Oil Filter Housing
D13H, D13J
VAH, VHD, VN

FSB 222-004, Oil Filter Housing

(January 2016)

W2059284

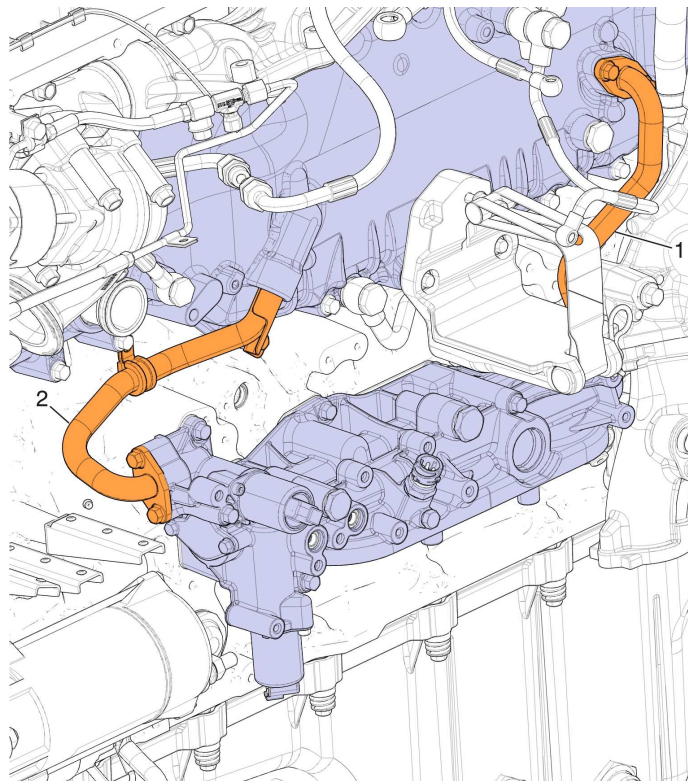
The introduction of a new style oil filter housing requires replacement of the oil cooler inlet pipe when replacing the previous style housing on US2010 and US2014 emission VOLVO D13 engines with an engine serial number less than 1125655. Installation procedures remain the same, refer to Function Group 22 in Impact for proper installation. The updated oil filter housing went into production September 2015.

- 1 Oil Cooler Outlet Pipe
- 2 Oil Cooler Inlet Pipe

Previous Housing Part Numbers	New Style Housing Part Number	Pipe Part Number
21811042, 22095768	22108170	22026543
